Wollongong Local Planning Panel Assessment Report | 27 November 2018

WLPP No.	Item No. 2
DA No.	DA-2018/973
Proposal	Residential - demolition of existing structures and construction of a 15 storey mixed use development comprising seven (7) commercial tenancies, 63 residential apartments and car parking for 91 vehicles
Property	28-32 Young Street and 29-31 Belmore Street, Wollongong
Applicant	ADM Architects
Responsible Team	Development Assessment and Certification - City Centre Team (NL)

ASSESSMENT REPORT AND RECOMMENDATION

East elevation

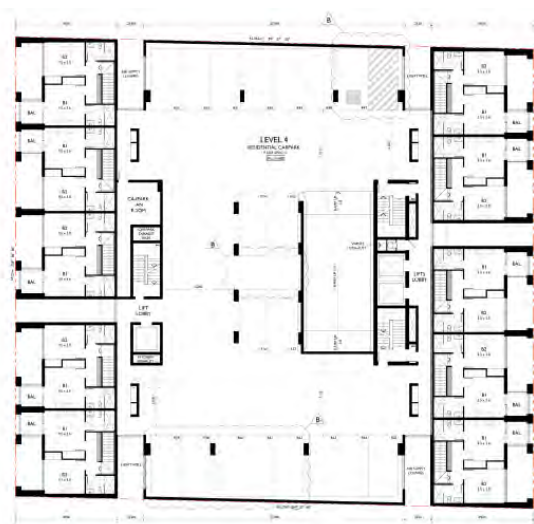
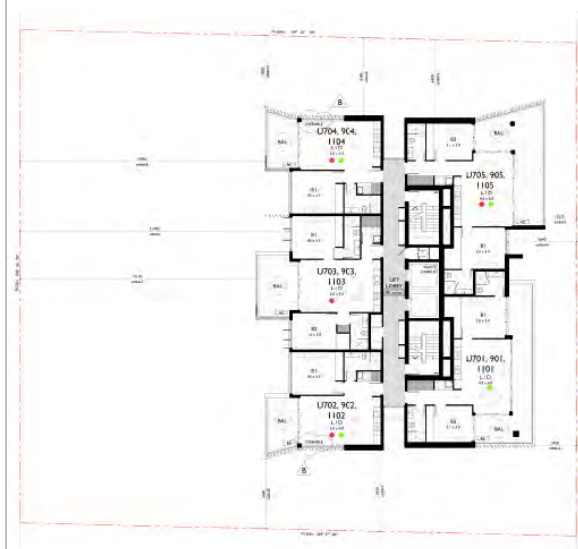
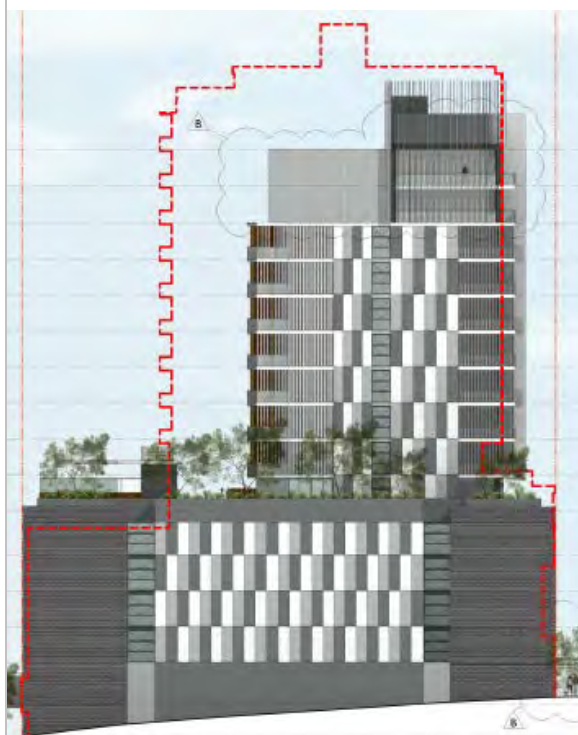
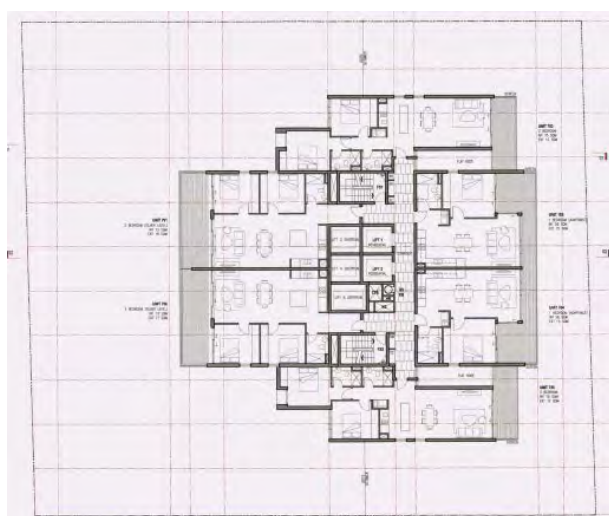
DA-2016/1061 comprised a mixed use development made up of a hotel and associated facilities up to level 6 with residential apartments above. That development had 3 and a half levels of basement car parking as well as recessed areas in the podium up to level 5.

Whilst there are some similarities between the two built forms, the current proposal is not a modification of that development. Further, the nature of DA-2016/1061 is significantly different in that it contained a hotel.

Title
DEVELOPMENT APPLICATION
CONTEXTUAL STREETSCAPE 1 OF 2

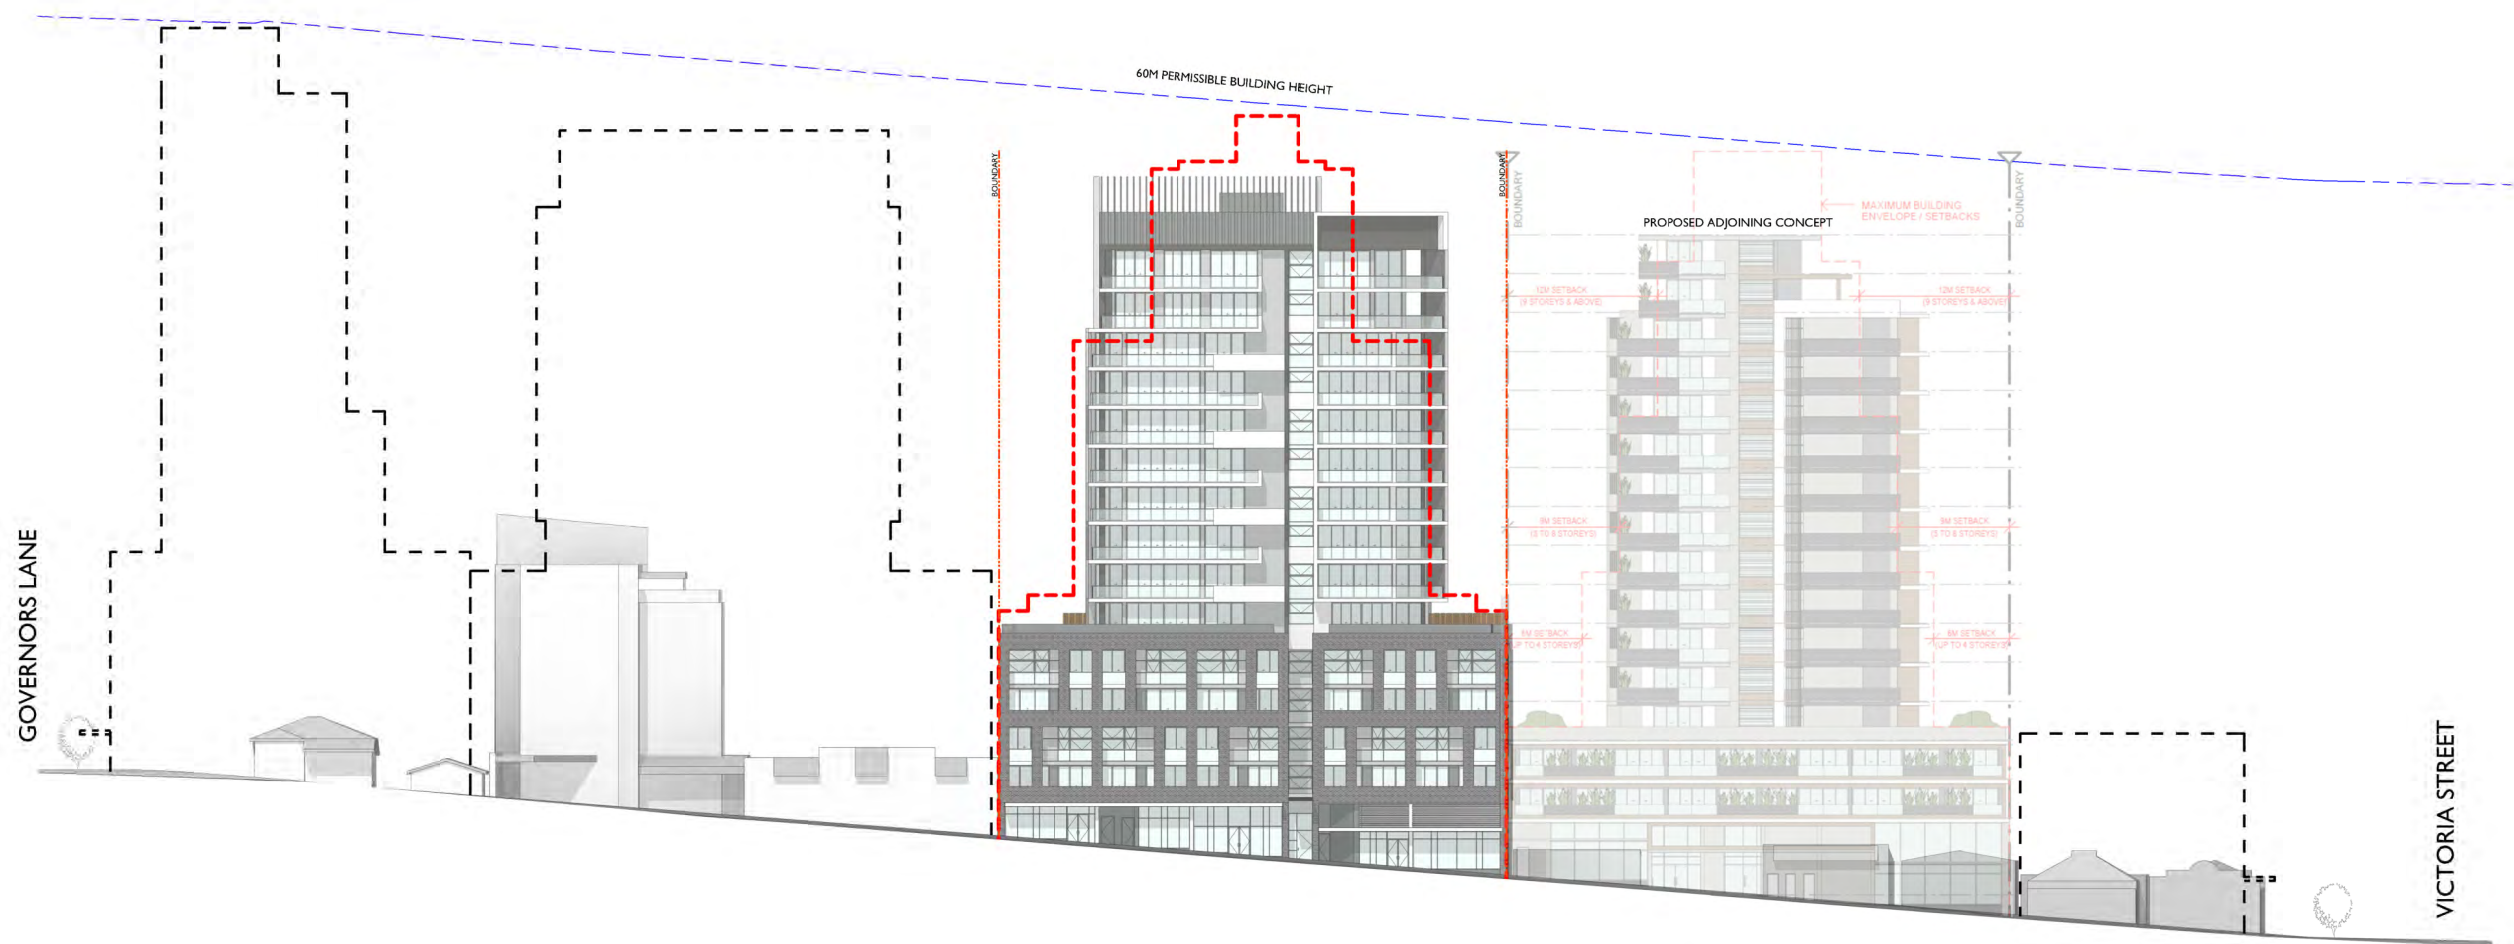
Should Council have particular concerns regarding the relationship between the adjacent podiums, it is respectfully requested that modification occur to the design of the adjacent building to the north, which is in the early stages of planning and which has not been the subject of in excess of 2 years of detailed design works since the original development application was submitted and approved in 2016.

The accompanying Contextual Streetscape Drawings prepared by ADM Architects have now been amended to reflect the concept plans of the adjoining building. A revised Clause 4.6 Exceptions to Development Standards Report, which considers a compliant built form on the adjoining land to the north, is contained in Appendix 1.

Title
DEVELOPMENT APPLICATION
SCREENING DETAILS

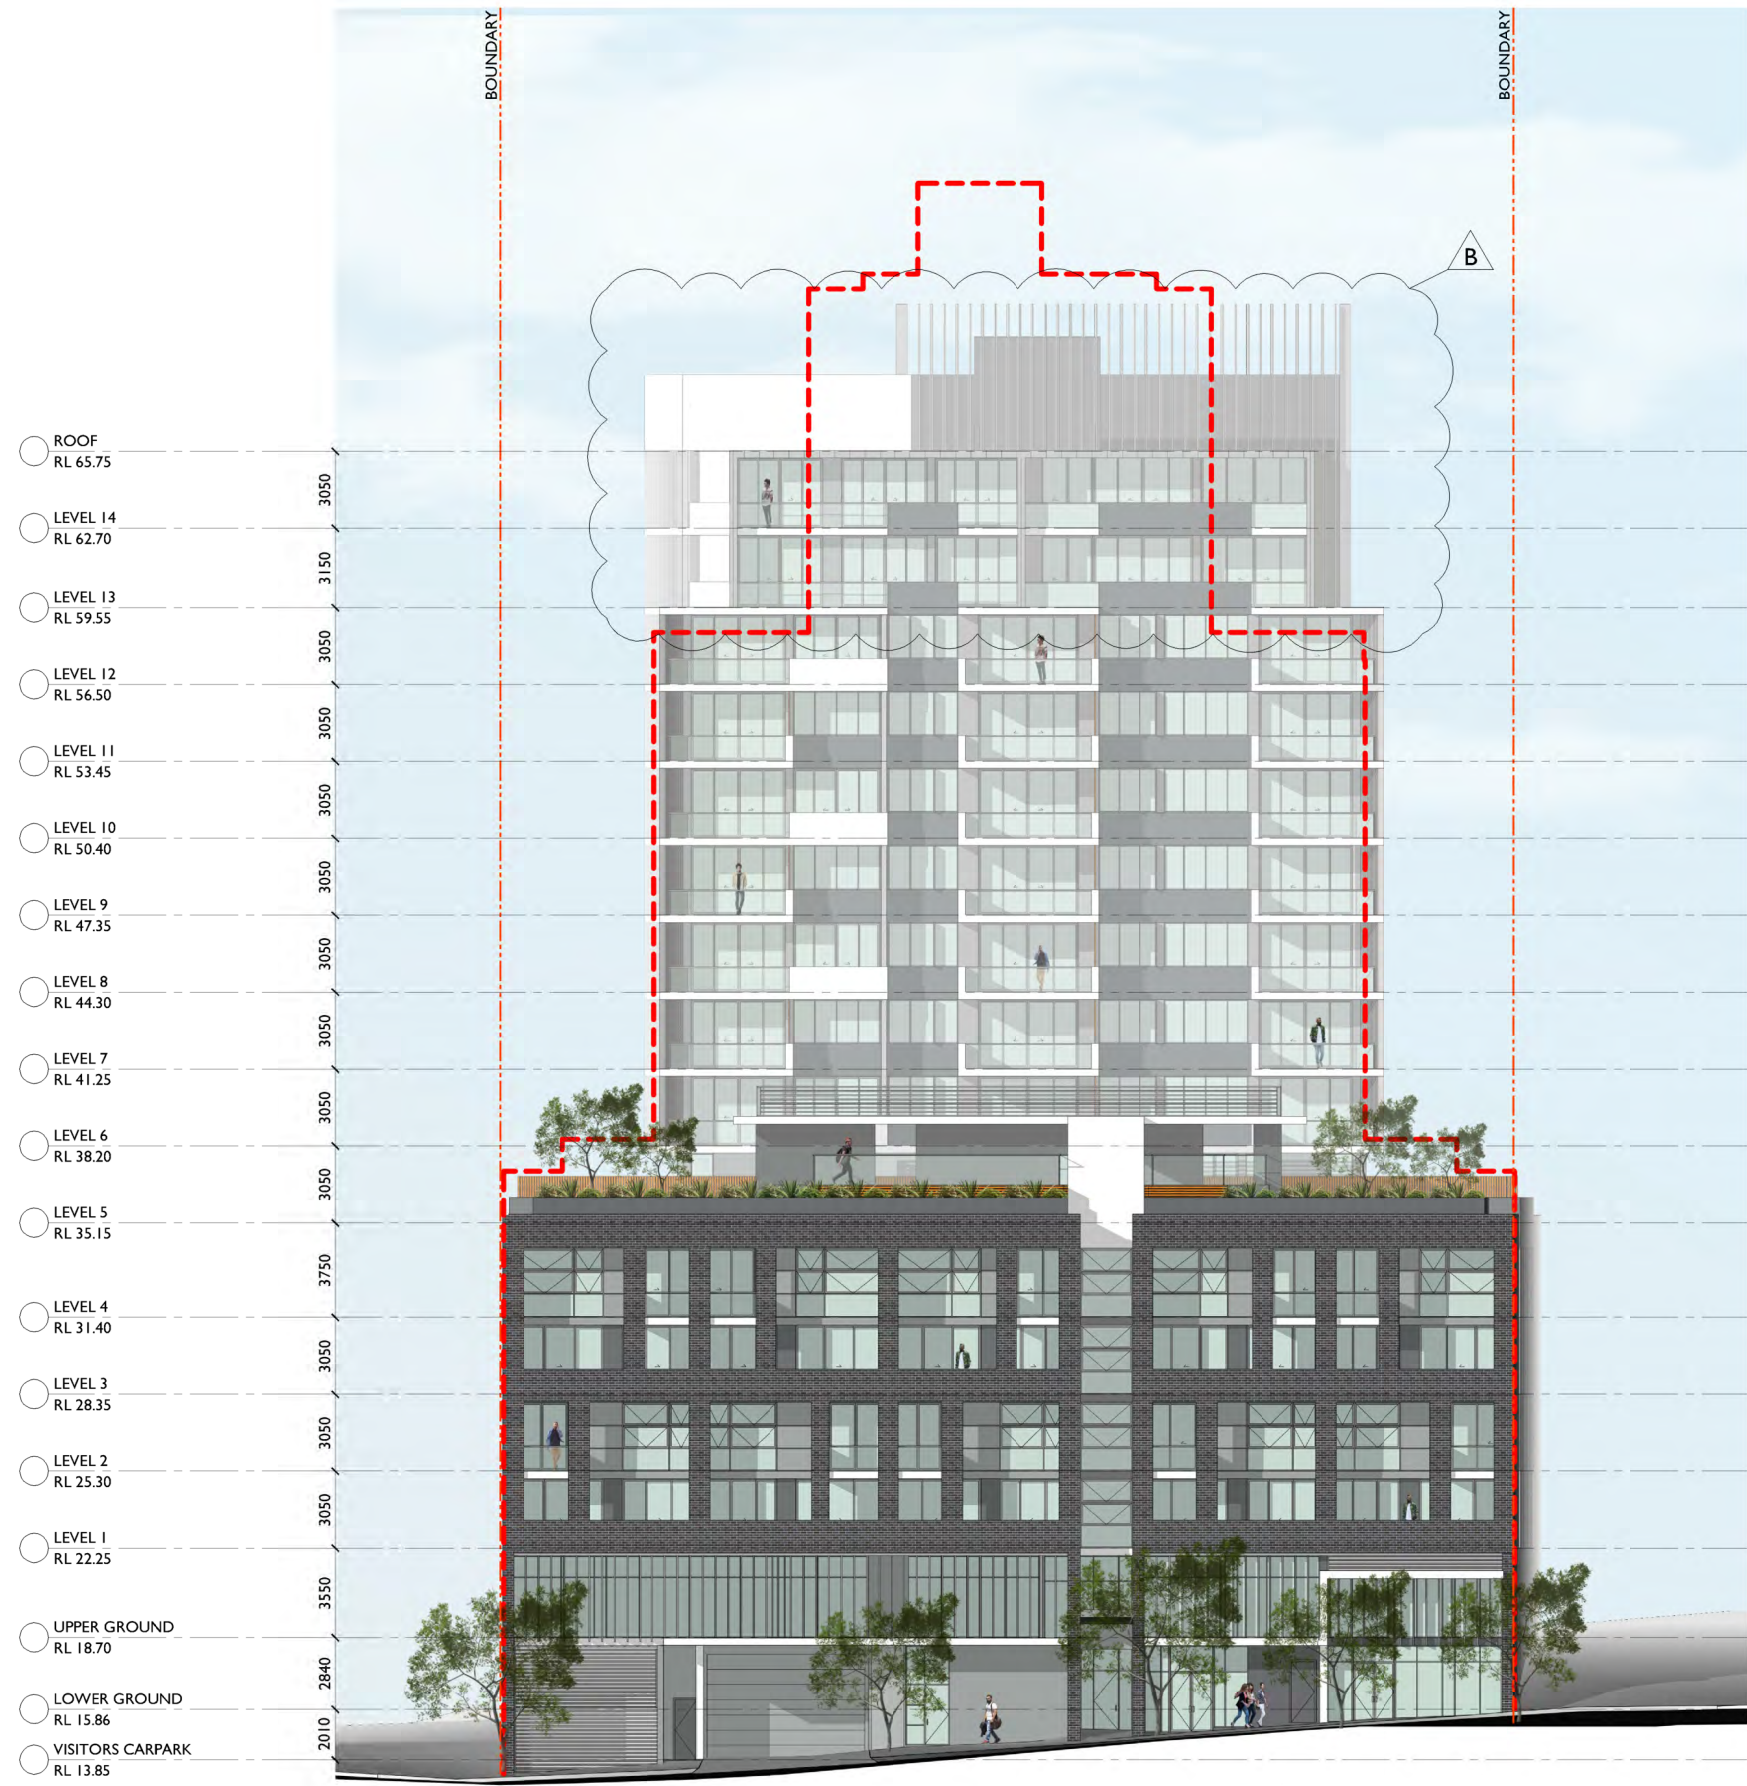
"On the residential tower corner balcony screening has been provided to the north and south to preserve visual privacy and ensure the predominant outlook is to the west or east away from the neighbour. These screens have now been detailed to demonstrate how privacy will be achieved. To ensure that this design intent is realised and compliance with the requirements of the ADG met, the applicant is required to provide dimension and angles of blades and openings, to be submitted."

A-115 Screening Details	<ul style="list-style-type: none"> Louvre larger scale detail has been added to this sheet as requested by DRP. Annotation added stating that the louvres are operable via manual winder.
A-201-206 Elevations & Sections	<ul style="list-style-type: none"> Level 13 & 14 amendments have been reflected on the elevations. Additional trees to the Young St elevation as per updated landscape plan.
A-302 Accessible plan:	<ul style="list-style-type: none"> The pre-adaptation plan has been deleted. Now an accessible unit only as recommended by the DRP (i.e universally accessible upfront – not after adaptation).
A-303-304 Pre & Post Adaptation Plan 2 of 3	<ul style="list-style-type: none"> Different unit type added as per amended 3 bed design
A-305-306 Pre & Post Adaptation Plan 3 of 3	<ul style="list-style-type: none"> Additional sheets have been added to the set to reflect plan changes as above.

The amended architectural plans now confirm that the louvres on the northern and southern windows of the corner units will be operable.

Table 2: Compliance with WLEP 2009 - Contravention of Clause 8.6 Building Separation in the B4 Mixed Use Zone

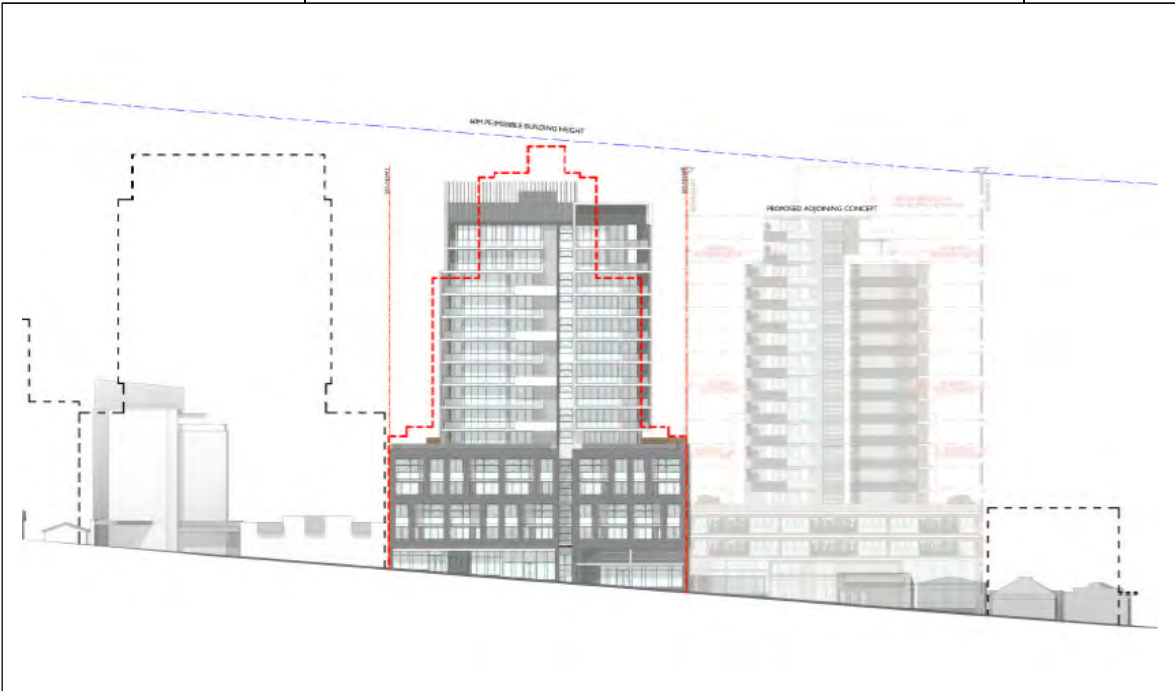
Development departure	Clause 8.6 Building separation within Zone B3 Commercial Core or Zone B4 Mixed Use
Is the planning control in question a development standard	Yes
4.6 (3) Written request submitted by applicant contains a justification:	
that compliance with the development standard is unreasonable or unnecessary in the circumstances of the case, and	Yes
that there are sufficient environmental planning grounds to justify contravening the development standard.	Yes

Clause 8.6 Exceptions to Development Standards	Response/Justification	Consistent/ Complies
<p><i>standards to particular development, and b) to achieve better outcomes for and from development by allowing flexibility in particular circumstances..</i></p>	<ul style="list-style-type: none"> At No.26 Young Street directly adjoining the site to the north, is a single storey commercial/light industrial building (car wash facility). Whilst a previous DA for an eight storey building was approved for No. 24 Young Street (DA-2007/1094), this approval appears to have lapsed. Hence, there are no existing or approved buildings for the sites to the north for buildings of above 1 storey. Therefore, there is no direct interface between the adjacent development to the north and any of the residential levels of the building. The only interface is limited to the Lower Ground/Upper Ground commercial levels of the building, which are sited on the side boundary, as required by clause 8.6. Currently compliance with the building separation requirements of clause 8.6 is therefore achieved to the north. However, consideration has been given to the potential compliance with the building separation requirements in the event that the adjacent site to the north is developed, noting that a 'Concept' Plan has been prepared and has been the subject of early discussions with Council. The extract of the revised Contextual Streetscapes (Young Street Aspect) prepared by ADM Architects as reproduced in Figure 1 below shows the outline of the 'concept' buildings on the sites to the north.

<p>Figure 1: Contextual Streetscape</p> 	<ul style="list-style-type: none"> Figure 1 confirms that, whilst compliance with the required 20m separation will not be achieved, compliance with the requirements of the ADG will be achieved to the walls and the principle balcony areas (excluding angles) at <u>Level 6-12</u> of the building (refer to larger scale diagram in architectural package for dimensions). The standards contained in the ADG are considered to be the more appropriate guiding standards which should be adhered to, noting that the
